FONTANA

AN ADDITION TO WICHITA, SEDGWICK COUNTY, KANSAS

RE: SUB 2004-36 -- One-Step Final Plat of Fontana Addition

CASE NUMBER: SUB 2004-36 -- FONTANA ADDITION

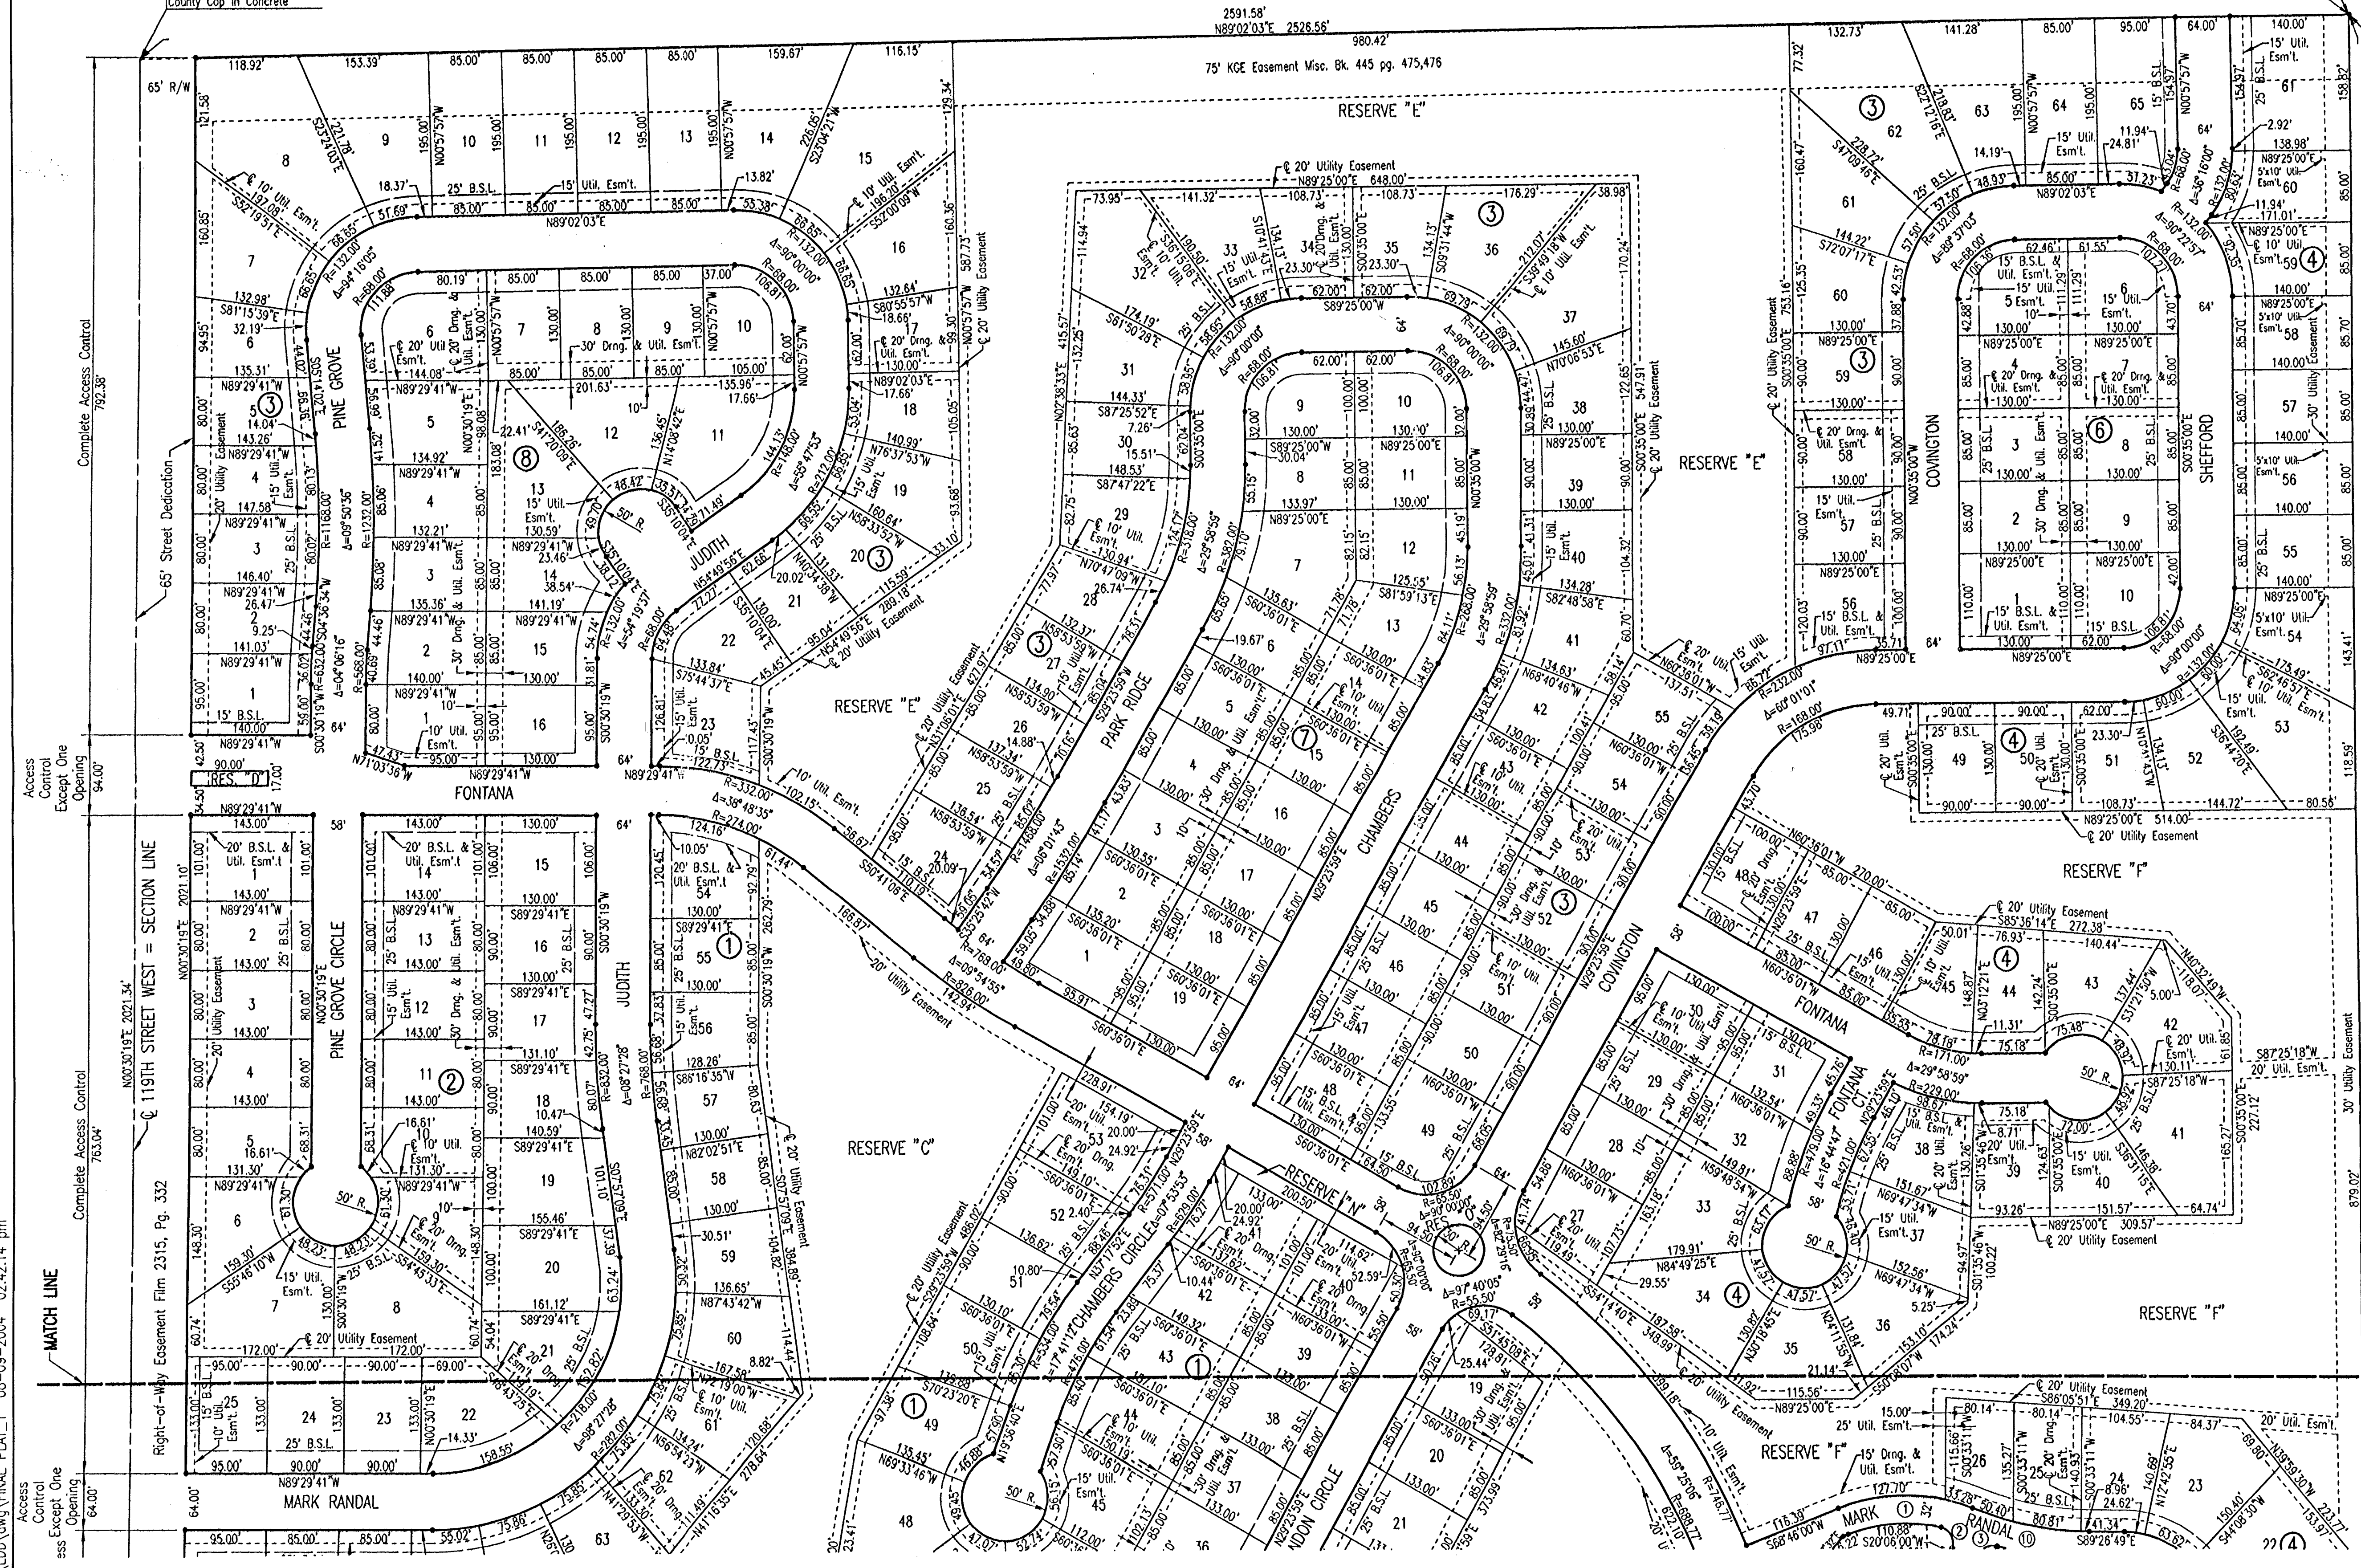
- A. Prior to this plat being scheduled for City Council review, annexation of the property will need to be completed. Upon annexation, the property will be zoned SF-5, Single-Family Residential and allow for the lot sizes being platted.

- B. The applicant shall guarantee the extension of sanitary sewer and City water to serve the lots being platted.
- C. If improvements are guaranteed by petition, a notarized certificate listing the petitions shall be submitted to the Planning Department for recording.

- D. City/County Engineering needs to comment on the status of the applicant's drainage plan. County Engineering requests a drainage plan.
- E. This site is located over the Equus Beds aquifer. The Equus Beds Management District has advised that the construction of ponds within the Reserves needs to be approved by the Division of Water Resources.

- F. The street right-of-way on 119th St. West needs to be 65 feet.
- G. County Engineering has requested a guarantee for paving of right and left turn lanes on 119th St. at Fontana. Traffic Engineering has requested petitions for left and right turn lanes along 29th North and 6% of the cost of a traffic signal.

The Subdivision Committee approved this plat without the traffic signal. It needs to be determined if 119th Street is annexed into Maize.

- H. A 58-ft right-of-way width is permitted for Fontana subject to "No Parking" on both sides of the street. The face of the plat shall be referenced accordingly.

- K. The Applicant shall guarantee the paving of the proposed streets. The guarantee shall also provide for sidewalks on at least one side of all through, non cul-de-sac streets and sidewalks along both sides of Fontana which functions as a collector. The Subdivision Committee approved this plat with sidewalks only on one side of Fontana.

- L. The plat's text shall include reference to "lots, blocks, streets and reserves" in the owner's certificate.
- M. The parking areas adjoining Reserves K and L need be included as "parking easements" within the Reserves. The easements need to be at least 20-feet deep and no wider than 50 feet. The parking easements shall be referenced in the plat's text specifying that the easements are granted for residential parking only and that no obstructions shall be constructed or placed within the easements.

- Q. City Fire Department needs to comment on the street length of Fontana Ct serving Lots 19 to 40, Block 1. The Subdivision Regulations limit urban cul-de-sacs to 800 feet in length unless an emergency access easement is proposed. The street length is approved. A modification on street length has been approved by the Subdivision Committee.

- R. In accordance with the City Fire Department access standards, a 20-ft roadway for ingress and 24-ft roadway for egress is needed at the Sonoma entrance.

- S. Since this plat proposes the platting of narrow street right-of-way with adjacent "15-foot street drainage and utility easements", a restrictive covenant shall be submitted which calls out restrictions for lot-owner use of these easements. Retaining walls and change of grade shall be prohibited within these easements as well as fences, earth berms and mass plantings.

- T. The applicant shall submit a covenant which provides for four (4) off-street parking spaces per dwelling unit on each lot which abuts a 32-foot or 58-foot street. The covenant shall inventory the affected lots by lot and block number and shall state that the covenant runs with the land and is binding on future owners and assigns.

- U. GIS needs to comment on the plat's street names. *New street names are needed as denoted on the Engineer's copy of the plat.*
- V. The platting text shall include language that a drainage plan has been developed for the plat and that all drainage easements, rights-of-way, or reserves shall remain at established grades or as modified with the approval of the applicable City or County Engineer, and unobstructed to allow for the conveyance of stormwater.
